ADDENDUM NO. 2 TO PLANS AND CONTRACT DOCUMENTS

MISSISSIPPI RIVER LONG DISTANCE SEDIMENT PIPELINE (BA-43 EB)
AND
BAYOU DUPONT MARSH AND RIDGE CREATION (BA-48)

JEFFERSON AND PLAQUEMINES PARISHES, LOUISIANA

JULY 19TH, 2013

PROJECT FUNDING SIGNS
DATE: MARCH 8, 2013
SHEET 81 OF 81

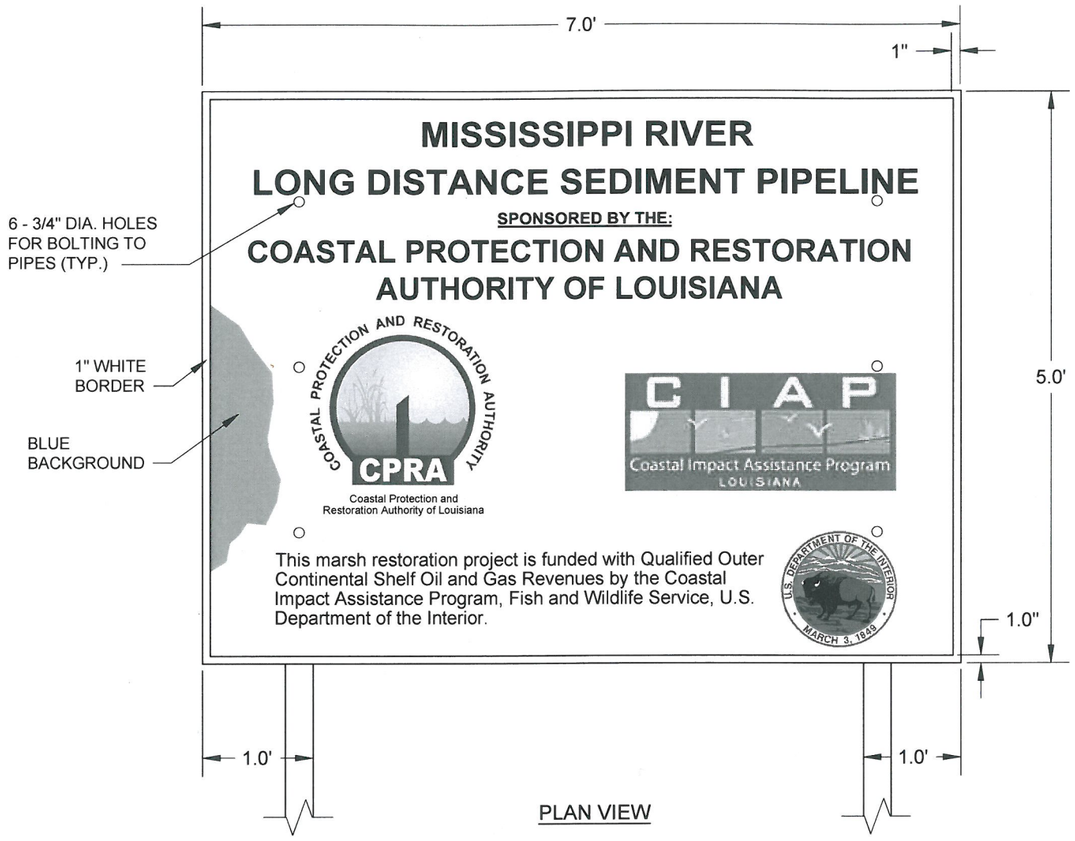
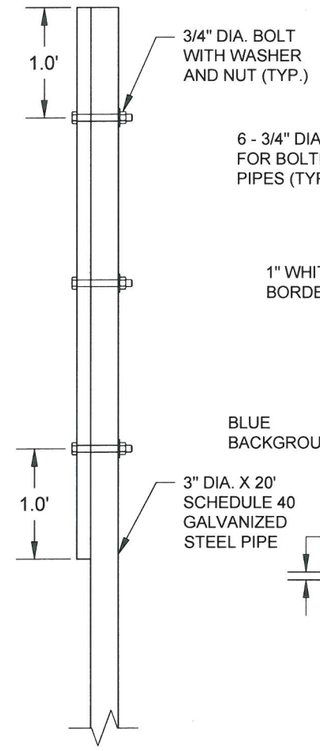
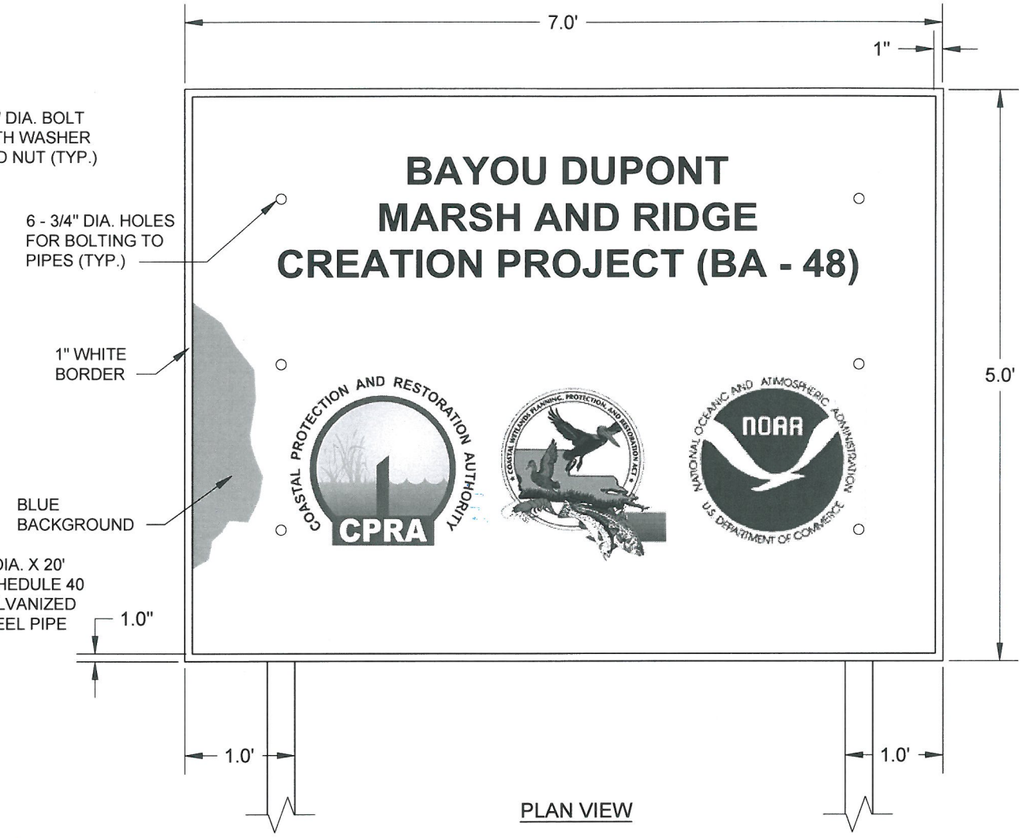
Sheet 81of 81: The wording at the bottom of the project funding sign shall be changed to read *"This marsh restoration project is funded with Qualified Outer Continental Shelf Oil and Gas Revenues by the Coastal Impact Assistance Program, Fish and Wildlife Service, U.S. Department of the Interior."*

Sheet 81 of 81: An additional project funding sign shall be added as shown.

FIGURE 1

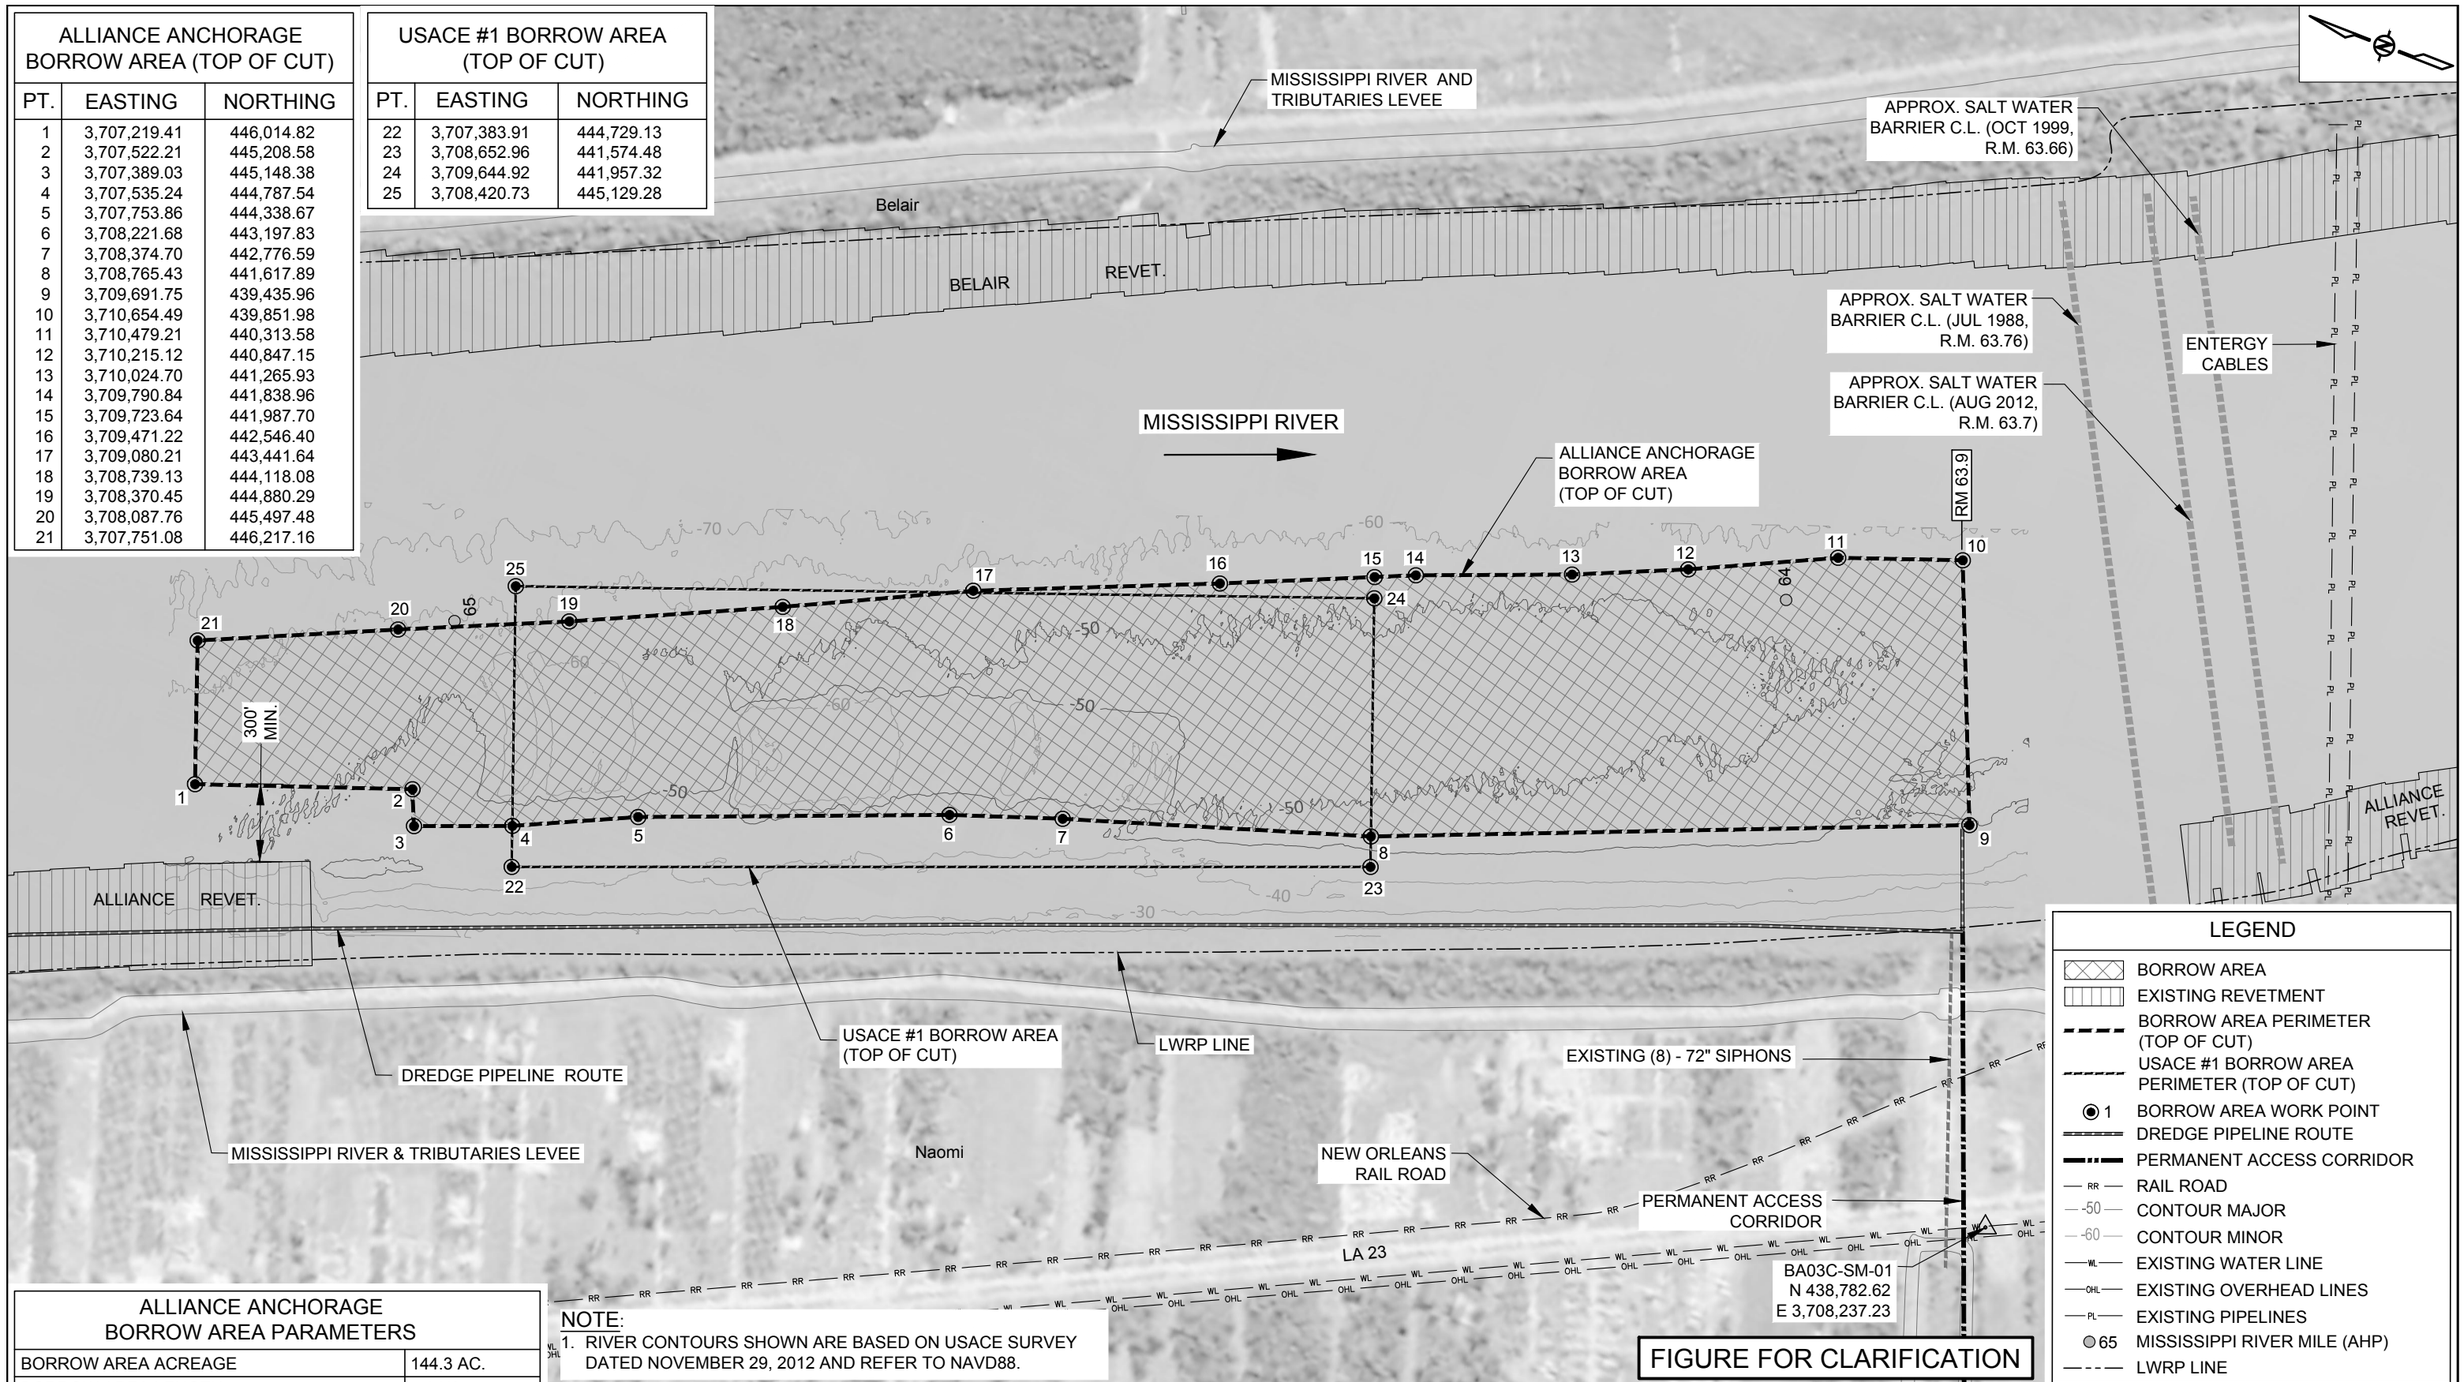
USACE Borrow Area#1 and the permit requirement to reserve 500,000 cy above -70 ft NGVD for the emergency saltwater barrier sill if required: The attached map (Figure 1) is provided for clarification showing both the permitted Alliance Anchorage Borrow Area for this work and the USACE#1 borrow area. Permit MVN-2009-1353-EFF special condition #9 states that "the reserve quantity must be located within the boundaries shown…" which is indicated as USACE#1 on the attached map (Figure 1).
